AMENDMENTS TO THE DRAWINGS

REMARKS

FIGURE 3

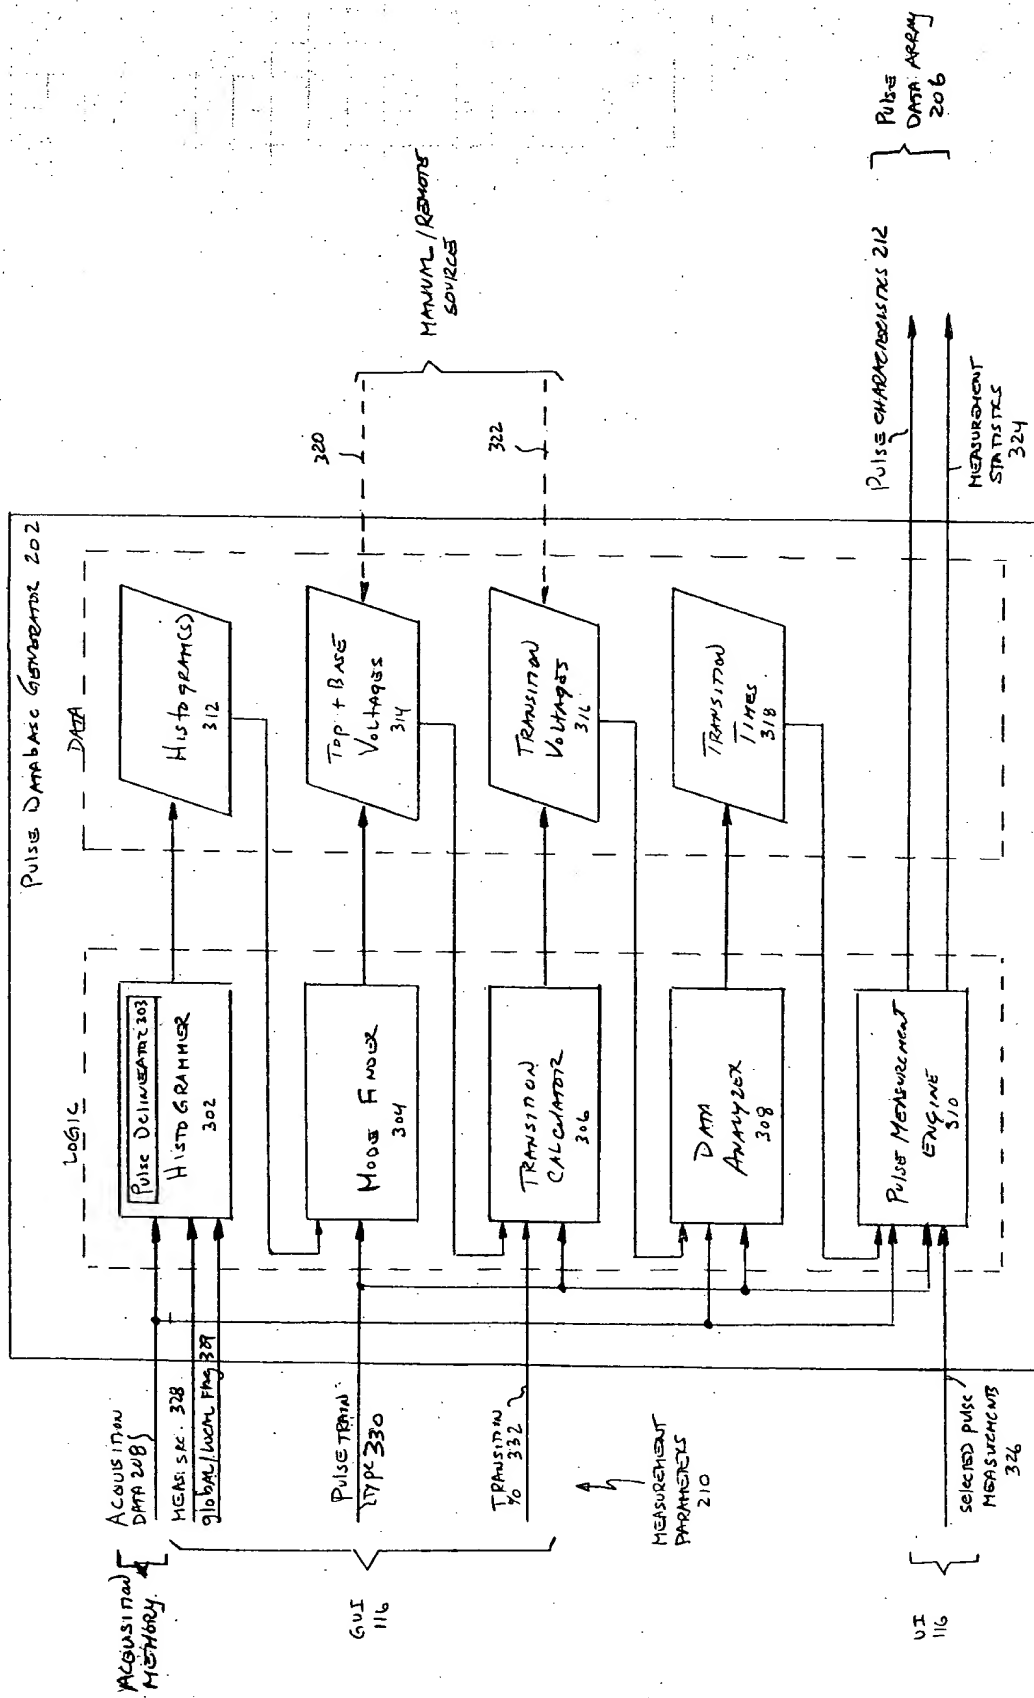
The attached one sheet of drawings includes changes to Figure 3. This sheet, which includes a proposed drawing change to Figure 3, replace the original sheet also including Figure 3. Reference "Pulse Train Type 332" has been changed to "Pulse Train Type 330"

4. Applicant identified an error in Figure 3. An informal drawing with red-lines correcting the error is submitted with this Amendment as Appendix B. In Figure 3, the reference Pulse Train Type 332 has been changed to Pulse Train Type 330. After receiving approval by the Examiner for the change, Applicant will submit corrected formal drawings.

FIG. 9A

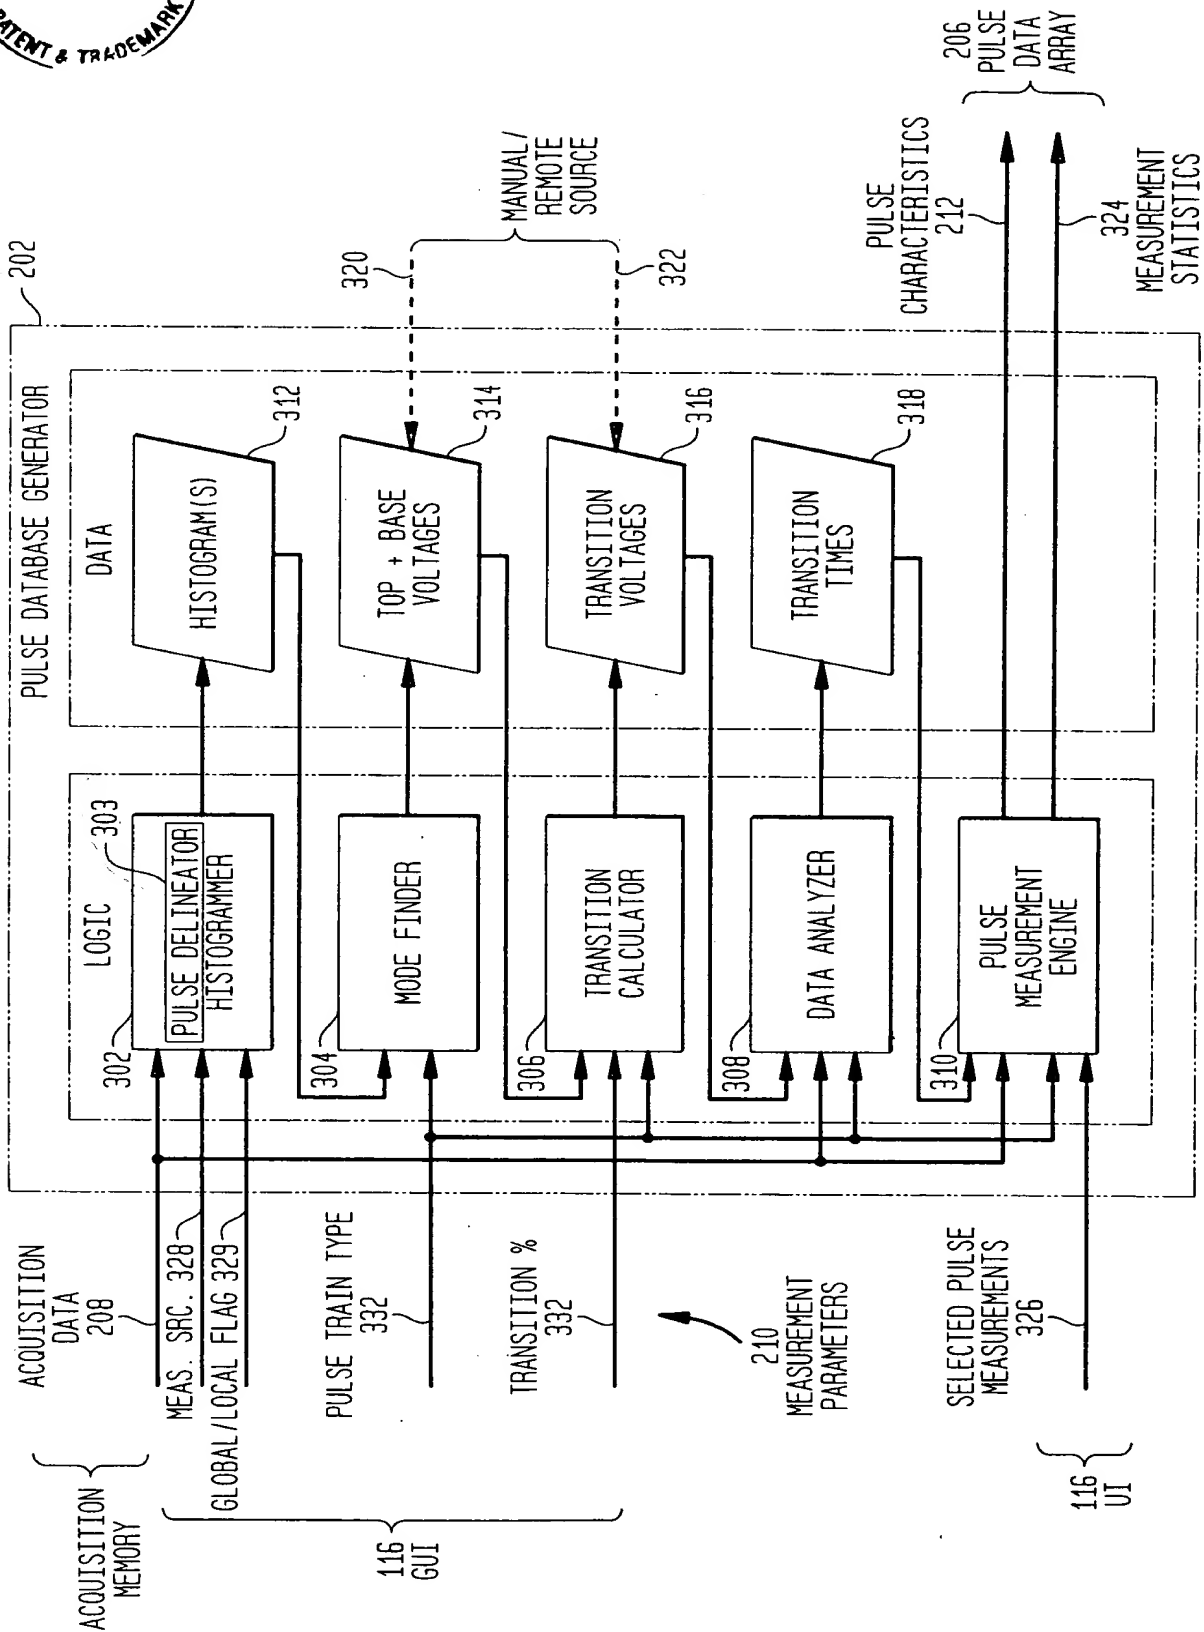
3. The Examiner has objected to drawing Figures 3 and 9 under 37 CFR § 1.84(p)(5) for missing reference number "303", and reference numbers "900", "916", "922", and "928", respectively, which are mentioned in the specification. In the Response filed January 08, 2004, Applicant argued that the reference numbers were included in the figures, but the Examiner has maintained the objection in the current Office Action. The Examiner further explains in paragraph 14 of the current Office Action that the Examiner sees in the figures the mentioned items, but that the labels are missing. To resolve this issue, Applicant submits as Appendix A a copy of the informal drawings filed with the original Application, with the disputed numbers highlighted. Because Applicant is unsure if the Examiner is referring to the informal drawings or the formal drawings, Applicant also submits in Appendix A a copy of the formal drawings, with the disputed reference numbers highlighted.
